CITY VIEW AVE. - LITTLE DIAMOND ISL.
105-N-1-2 LOTS 45-53 ISL.

PERMIT TO INSTALL PLUMBING 105-1-2

STATE OF MAINE
DEPARTMENT OF HUMAN SERVICES
AUGUSTA, MAINE 04333

RAND
LEACHING
CHAMBER
SYSTEM

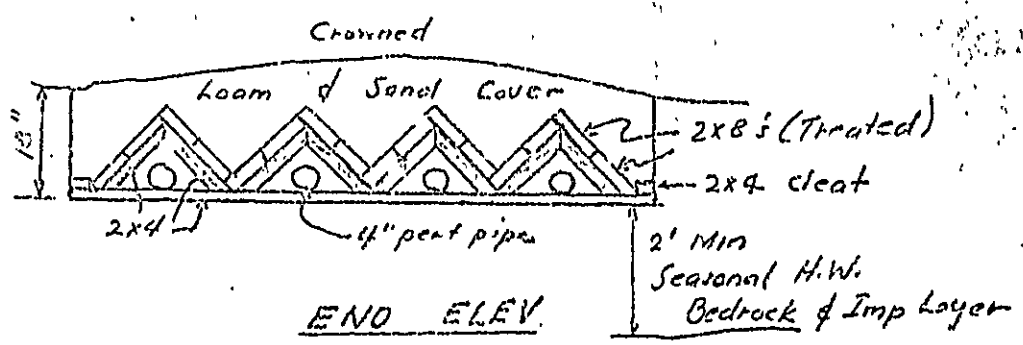
We are in receipt of your revised leaching chamber system dated May 15, 1976.

In principal, we feel that these chamber systems you propose may be a simple and economical answer for the Maine islands where there is difficulty in obtaining stone and sand and constructing conventional disposal systems.

We have several concerns about the sizing of your systems, particularly in the Medium and Large Systems where we question whether the size would be adequate if you are installing them directly over silts where percolation rates are in excess of 60 minutes per inch. The 24 x 24 plank chamber systems, assuming the mat is permitting factor for ultimate failure, appear to be adequate to handle approximately 150 gallons per day.

Persons having these systems installed should be aware of the fact that it may be necessary from time to time to remove the planks and physically remove the mat or at some point in time add on to the systems should a problem occur.

The Department is prepared to permit the installation of these plank chamber systems on the islands in Casco Bay on a trial basis, with the understanding that should they appear to be undersized that they will have to be added onto.
